B2 Local Authority report on 37 Grosvenor Avenue site investigation

37 Grosveno	r Av	enue		Ref: TQ 210 755
Site Address:	Mortlake				521073-E 175613-N
	London				521107-E 175618-N
	SW14 8BT				521114-E 175582-N
	<u> </u>			SW:	521078-E 175582-N
Contractor: LB Environmental	Contractor: LBH Geotechnical and Environmental				: July 1993
Contractor Rep	oort Ref: LBH1	44			nt: London & Quadrant Housing ciation

Plan A

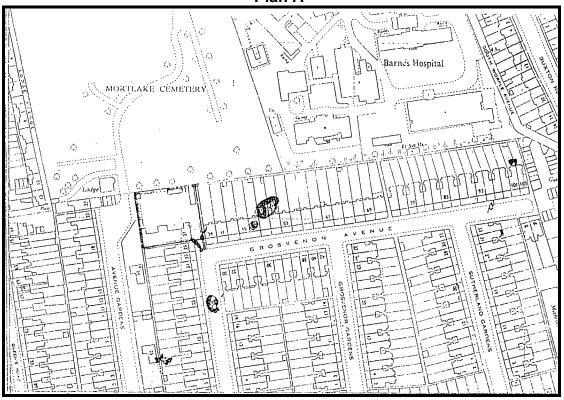
Has a written sampling strategy been provided?	N		
Has a suitable borehole plan been provided?	Y	See Plans A & B.No north arrow.	
Is the sampling frequency and pattern suitable?	N		
Is the proposed groundwater/gas sampling strategy suitable?	N	None proposed.	
Were sample locations and sampling undertaken as specified on the site plan and sample plan?	Υ		
Will the proposed sampling provide a reliable data set?	N	No of samples provided for analysis not known.	
Site Investigation		Comments	
How many and what type of boreholes were undertaken at the site:		Four trial pits (unspecified depth).	
Are the type and frequency of monitoring installation adequate?	N	None installed.	
Have appropriate logs been presented to BS5930 standard?	N	Basic geotechnical logs.	
Was any visual/olfactory evidence of contamination encountered during the investigation?		Unknown	
Have any photographs been taken?	N		
Field Tests		Comments
